RE: La Cumbre Cold Storage Building
Grading and Drainage Plan
Engineer's Stamp Date 2-13-2017 (File: G16D103)

Based upon the information provided in your submittal received 2-13-2017, the above referenced Grading and Drainage Plan cannot be approved for building permit until the following comments are addressed:

A1 GRADING AND DRAINAGE PLAN

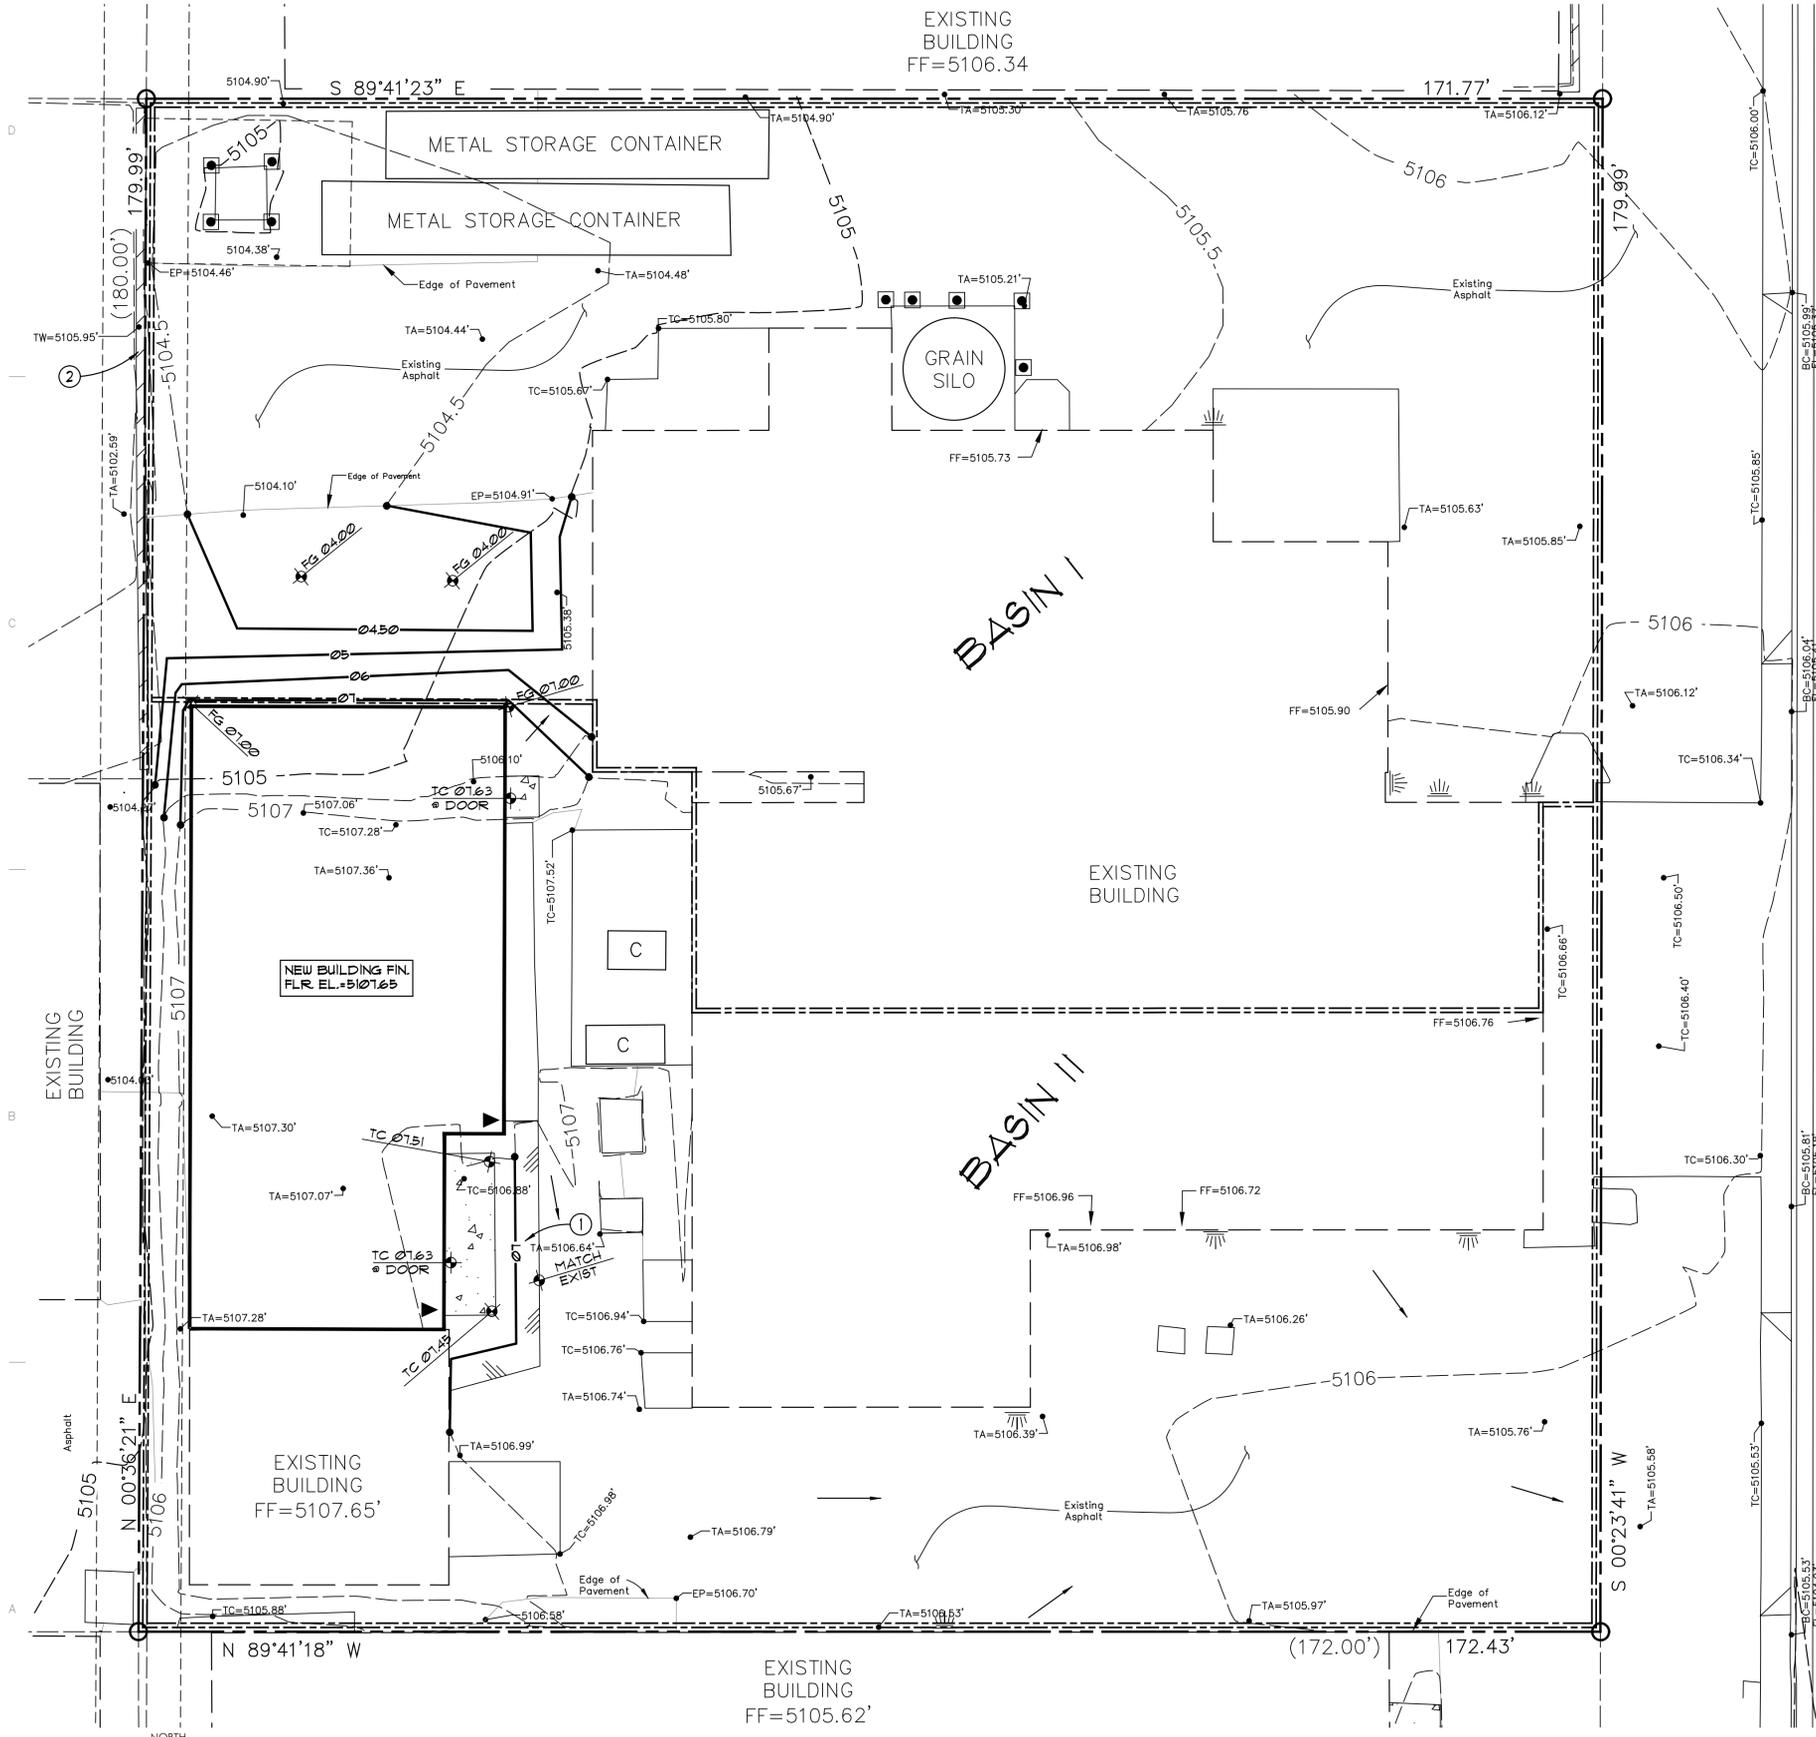
1. Provide offsite flow narrative.
2. It appears the north portion of the site will drain to the northwest end of the site and will not outfall to the Girard Ave. NE. and the west side the new building it drains to the southwest corner.
3. An updated Traffic Circulation Layout will be required. Is there a revocable permit for the use of Right of Way for parking?
4. Grading plan must reflect any changes to the parking spaces.
